**U.S. DEPARTMENT OF ENERGY (DOE) REVIEW OF U.S. NUCLEAR REGULATORY COMMISSION'S (NRC) REPOSITORY DESIGN AND THERMAL-MECHANICAL EFFECTS ISSUE RESOLUTION STATUS REPORT, REVISION 2**

Enclosure:  
Comments on Issue Resolution Status Report,  
Revision 2 Key Technical Issue: Repository  
Design and Thermal-Mechanical Effects

**COMMENTS ON ISSUE RESOLUTION STATUS REPORT,  
REVISION 2, KEY TECHNICAL ISSUE: REPOSITORY  
DESIGN AND THERMAL-MECHANICAL EFFECTS**

Figure 1. Shear Strength Curve Based on the Hoek and Brown (1997) Approach (GSI=62,  $\sigma_{ci}$ =167.9 MPa,  $m_i$ =19.68)

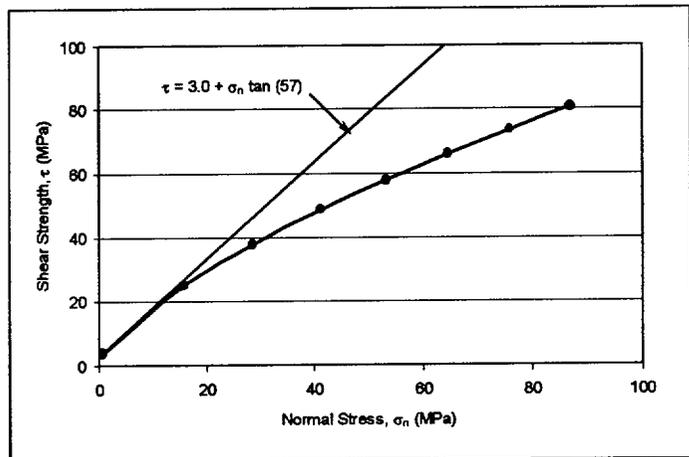
DOE believes that its approach is consistent with the reference cited by the NRC and that the apparent discrepancy is due to the range of the confining pressures used for the curve-fit of the non-linear Hoek and Brown curve to the linear Mohr-Coulomb criterion. The source referenced by the NRC, *Practical Estimates of Rock Mass Strength* (IRSR Reference Hoek and Brown 1997), correctly identifies that “...for values of  $\sigma'_n$  of less than 5 MPa, the straight line, constant  $C'$  and  $\phi'$  method overestimates the available shear strength of the rock mass by increasingly significant amounts as  $\sigma'_n$  approaches zero. Under such circumstances, it would be prudent to use values of  $C'$  and  $\phi'$  based on the tangent to the shear strength curve in the range of  $\sigma'_n$  values applying in practice.” In-situ stresses at Yucca Mountain are relatively low,

in the range 1 to 3 MPa (SNL 1996). Radial stress is zero on the excavation surface and remains small in the vicinity of the excavation profile. The range of confining, or normal stresses, is in the lower non-linear portion of the Mohr-Coulomb failure envelope. DOE utilizes practices recommended by Hoek and Brown 1997, whereby stability analyses typically use a low cohesion and moderately high friction angle.

DOE suggests that utilizing low  $\phi$ , as predicted by the NRC may result in a design that is excessively conservative. DOE believes that using a lower range of normal stress is appropriate (see Figure 1), and friction angles of  $57^\circ$  to  $58^\circ$  are considered more representative of actual conditions observed in the Exploratory Studies Facility and Enhanced Characterization of the Repository Block Cross Drift where the rock mass cohesion of the TSw2 geologic unit is in the range of 1.9 to 3.9 MPa. Figure 1, below, identifies a single tangent point or solution for the low stress range of  $\sigma_1 - \text{vs} - \sigma_3$  values (where  $\sigma_1$  and  $\sigma_3$  are maximum and minimum principal stresses) calculated using the Hoek-Brown failure criterion (e.g., IRSR references Hoek, 1994; Hoek and Brown, 1997). Multiple tangents are used to determine the range of  $c$  and  $\phi$  that best describes the linear fit for this section of the curve. Based on tests conducted on core specimens collected from boreholes along the alignment of the ESF North Ramp and Main Drift, the friction angles ranged from  $46$  to  $58^\circ$  (IRSR reference CRWMS M&O, 1997h, Table 5-32).

Based on the discussion provided above, DOE recommends that the current IRSR narrative discussion (Section 4.3.3.2, Page 31, Paragraphs 2 and 3) be replaced with the following:

The values for the rock-mass strength parameters  $c$  and  $\phi$  currently proposed for YM (CRWMS M&O, 1997a) were estimated by fitting straight lines to sets of  $\sigma_1 - \text{vs} - \sigma_3$  values (where  $\sigma_1$  and  $\sigma_3$  are maximum and minimum principal stresses) calculated using the Hoek-Brown failure criterion (e.g., Hoek, 1994; Hoek and Brown, 1997).

The procedure presented by Hoek and Brown (1997) for estimating  $c$  and  $\phi$  is based on the GSI index. The values of this index can be determined through geologic mapping of the rock mass following guidelines described by Hoek and Brown (1997) or estimated through correlations with  $Q$  or RMR. The values of  $c$  and  $\phi$  obtained using this procedure (Ofoegbu, 1999) with the TSw2 section of the ESF  $Q$  data (Figure 2) are given as functions of  $Q$  in Figure 4. The figure shows  $\phi$  varying from about  $28^\circ$  to about  $35^\circ$  as  $Q$  varies from about 0.73 to about 13.6. These values of  $\phi$  are much smaller than the DOE values presented previously. The difference between the CRWMS M&O (1997a)  $\phi$  values of  $57$ - $58^\circ$  and the values in Figure 4 ( $28$ - $35^\circ$ ) for the same range of  $Q$  values is quite significant in

The practice of using values of  $c$  and  $\phi$  based on the tangent to the shear strength curve in the range of normal stress values is recommended by Hoek and Brown (1997) because of the low normal, or radial stress around the opening. The range of radial stresses around the opening is in the lower non-linear portion of the Mohr-Coulomb failure envelope, where the method of using a constant  $c$  and  $\phi$  from the broader range of normal stresses overestimates the available shear strength of the rock mass at the vicinity of the tunnel opening. Friction angles of 57 to 58° are considered to be more representative of actual conditions observed in the Exploratory Studies Facility and Enhanced Characterization of the Repository Block Cross Drift, where the rock mass cohesion of the TSw2 geologic unit is calculated in the range of 1.9 to 3.9 MPa.
